Addendum to
Ecological Impact Assessment

Coventry Stadium
Binley Woods
Warwickshire

Brandon Estates Limited

(21.10.2021)

Figure 1: Locations of blocks of trees with the potential to support bat roosts.

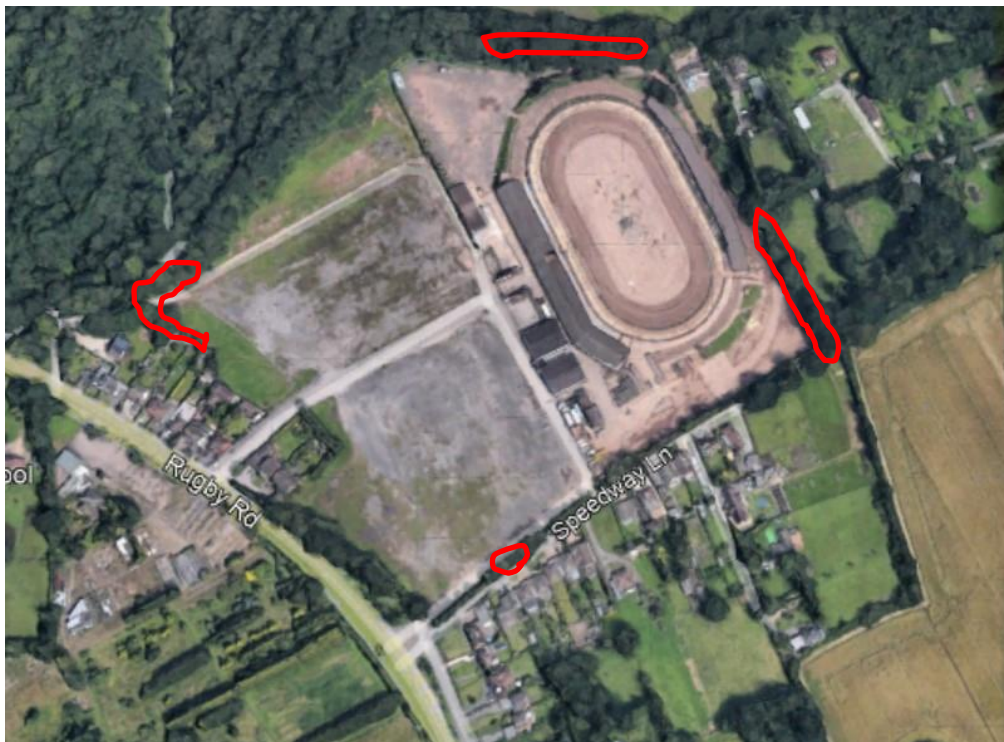
"No mention was made in the Ecological Impact Assessment (EclA) or the Bat Roost Assessment about the suitability of the trees within the site for roosting bats. Presumably an assessment would have been made as part of the EclA/Roost Assessment. Confirmation of this and recommendations for mitigation/precautionary working measures for removal of trees will be required prior to determination."

The EclA contained general references to the suitability of trees for bats, however, following a repeat site visit undertaken by George Burton on the 04/10/2021 during which a preliminary ground level roost assessment of trees was undertaken; four groups of trees with features which are suitable for roosting bats were identified. The locations of these trees are indicated in red on Figure1 below.

Trees with bat potential will be identified on the Construction Environmental Management Plan (CEMP) and will be retained and protected wherever feasible. In addition to the tree root protection areas a minimum fenced, protection zone of 10m will maintained during the construction period. Should it be necessary to remove any of the trees identified as having bat potential then further survey work in accordance with best practice as set out in "Bat Survey for Professional Ecologists, 3rd Edition, Bat Conservation Trust will be undertaken. This would comprise an inspection of the potential roost features by means of tree climbing or the use of cherry pickers. The timing of the inspection may need to be adjusted to take account of nesting birds.
